## Preliminary Drainage Report

# Waterview East Commercial El Paso County, Colorado

PCD Filing No.: **SP-22-009**

Prepared: May 18, 2022

DR-EX

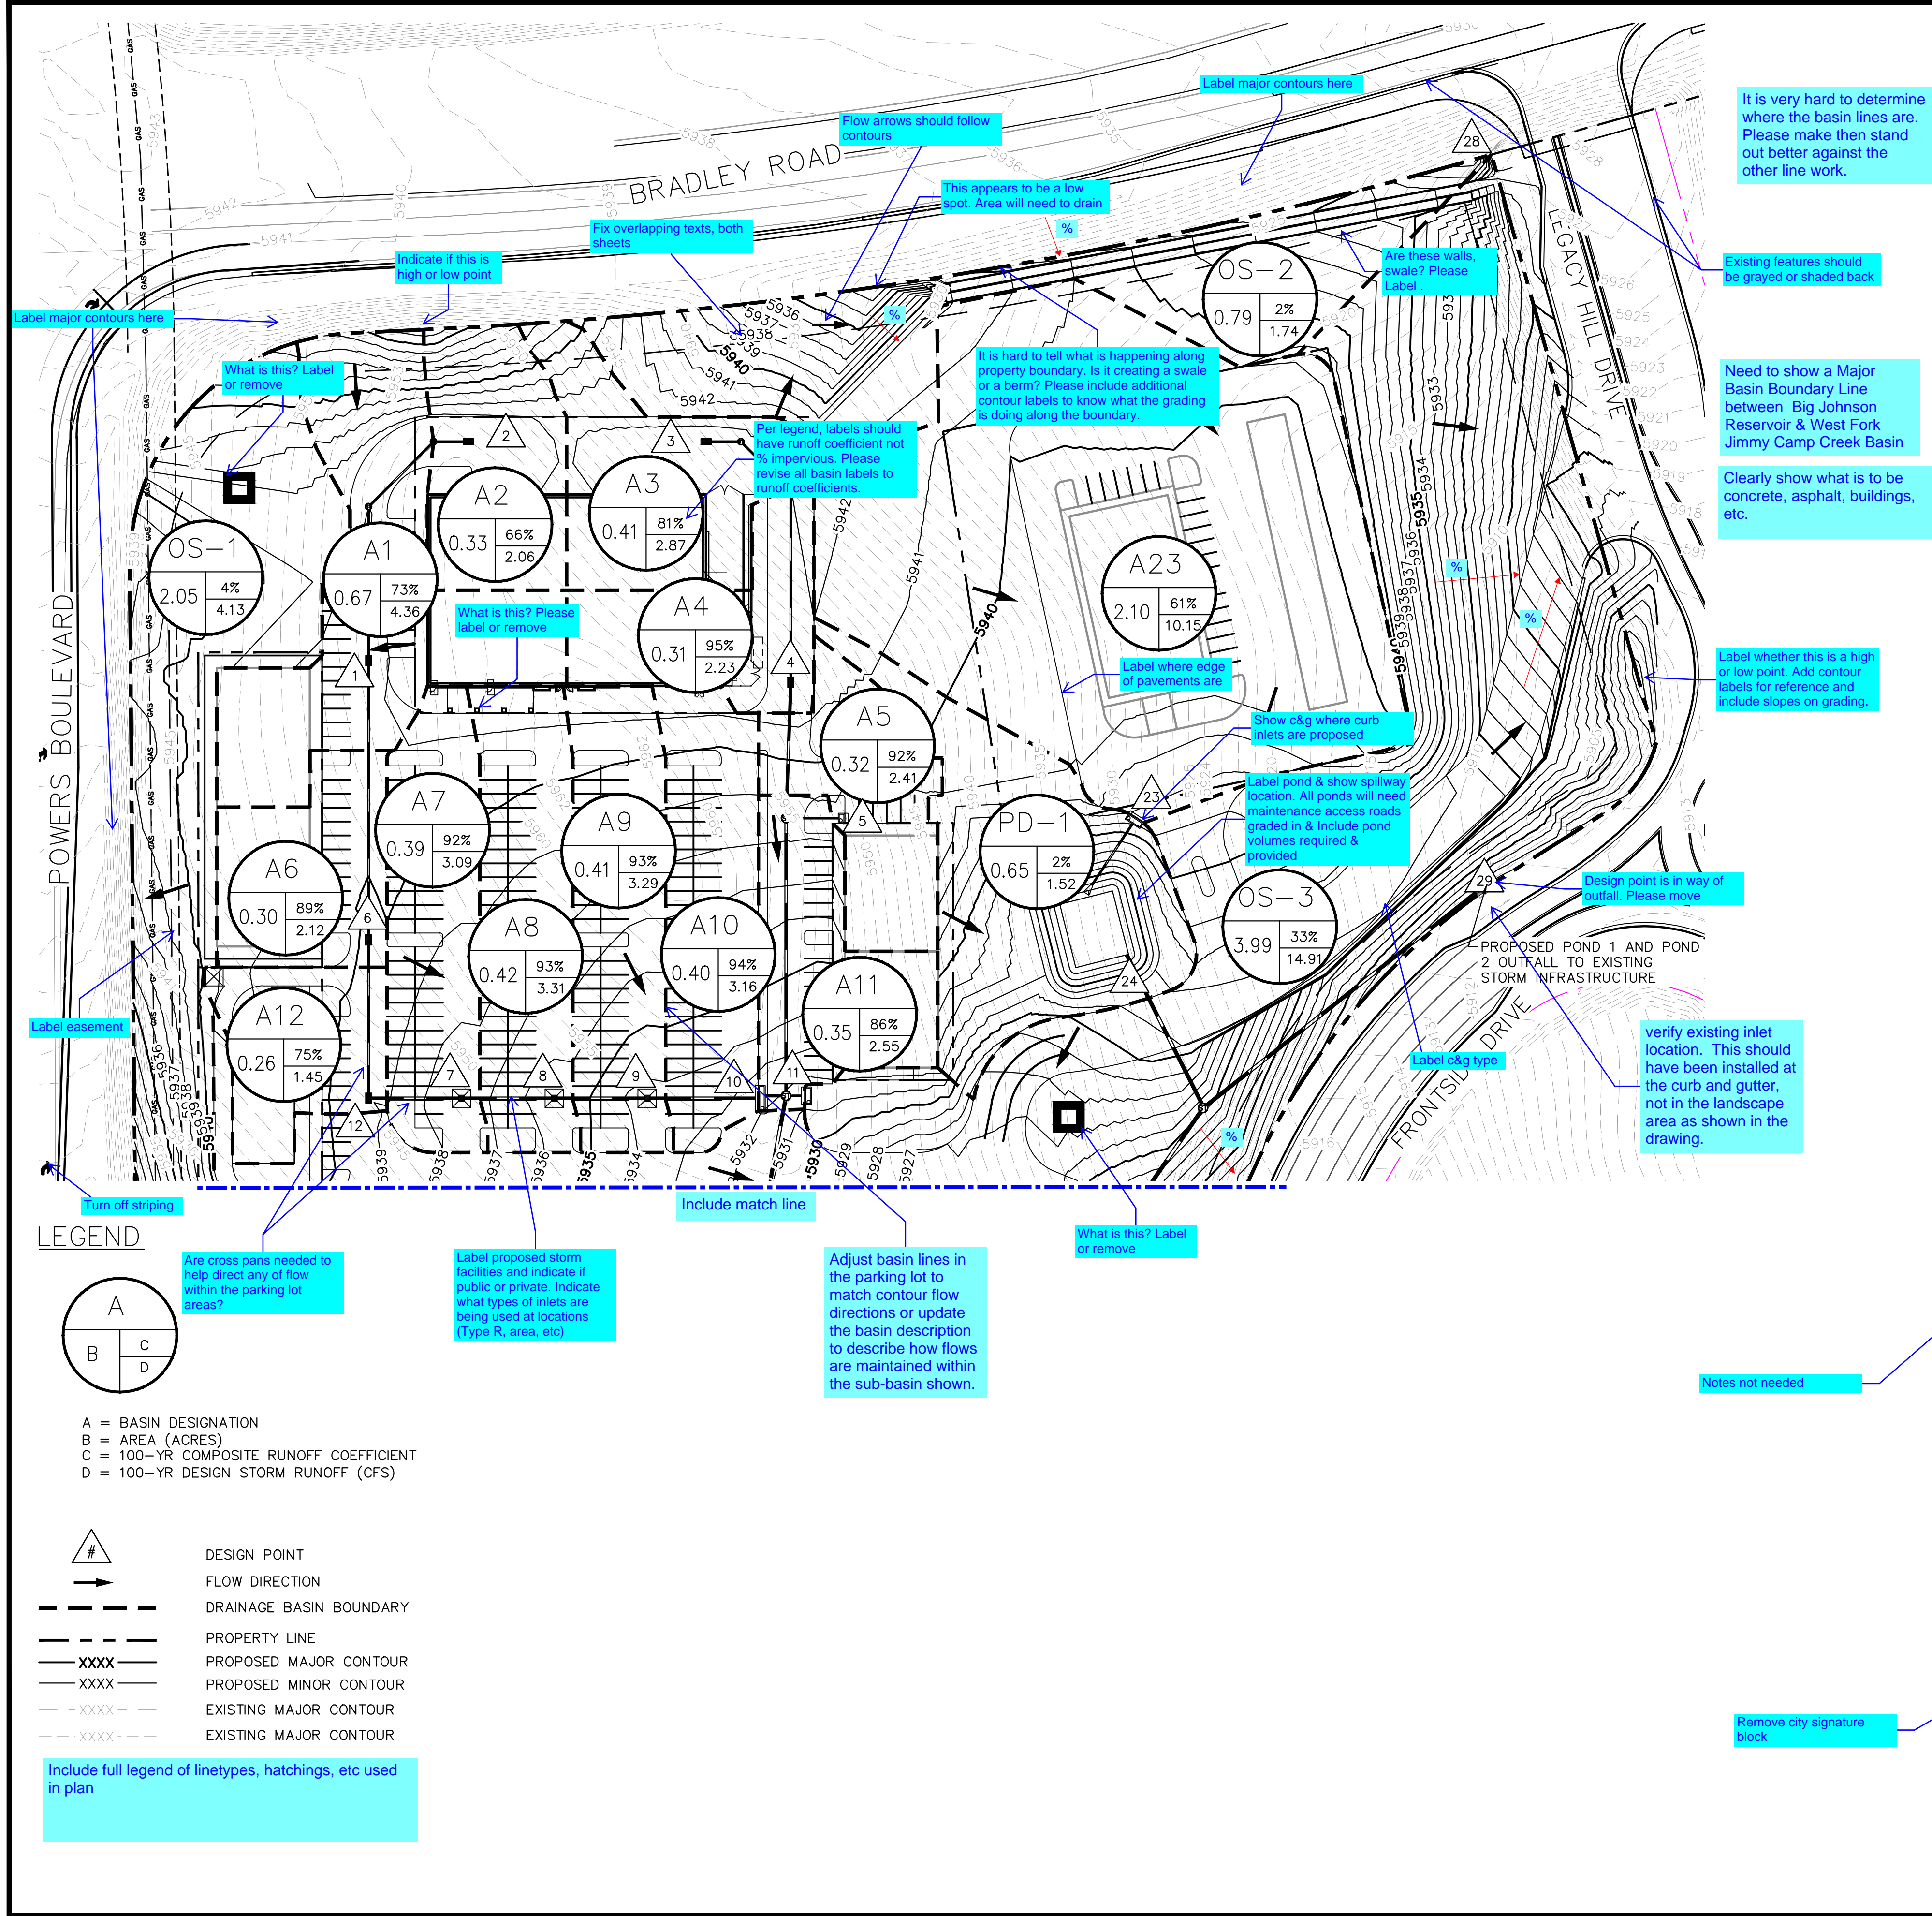
Provide the combined/routed flows for DP 29. This must be less than or equal to the MDDP

Remove city signature block

Include full legend of linetypes, hatchings, etc used in plan
